THE ENTRANCE PENINSULA COMMUNITY PRECINCT

06 April, 2011

Subject: **SUBMISSION ON TUGGERAH LAKES FLOODPLAIN
RISK MANAGEMENT STUDY.**

2004 Caterpillar 615C II

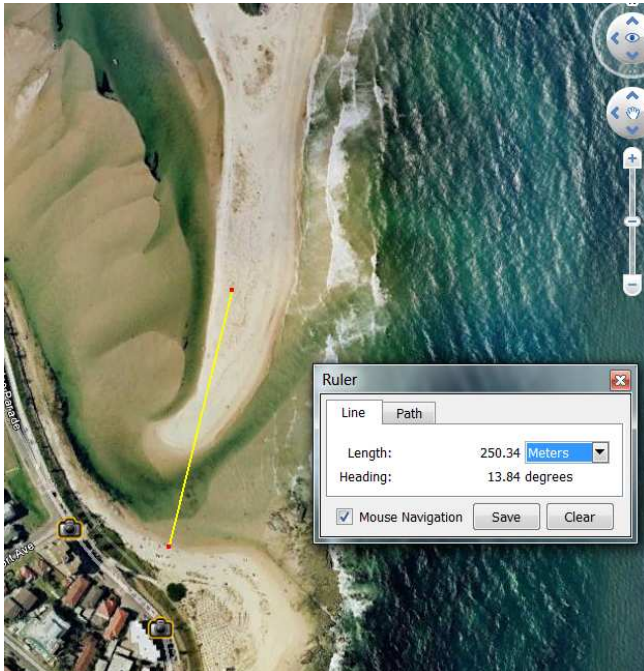
TEPCP requests that Council seriously considers- that by permanently maintaining a modified berm level 0.1m above the normal level of the lake to provide a 250m wide sand bar that is soon over topped in time of flooding as a good and achievable compromise to trying to open the channel itself.

- Adequate warning time is not an issues.
- A self elevating scrapper could be purchased by Council to remove the sand and spread it on North Entrance Beach at a cost less than one years dredging.
- The rate of rise of Tuggerah Lake: Above (say) 1.0 m AHD where the equipment would become bogged is not an issue.
- It is a safe option. The equipment and labour would work in a fine and calm weather, not in the harsh environment (rain, wind, ocean waves, rising water level, possibly darkness). that trying to open the channel in time of flood would involve.
- There is a very low risk to life and loss of equipment.

- It is a better option than channel dredging because it would be more effective in reducing flood levels.
- It is a more cost effective option to dredging than spending \$400,000.00 per year on dredging
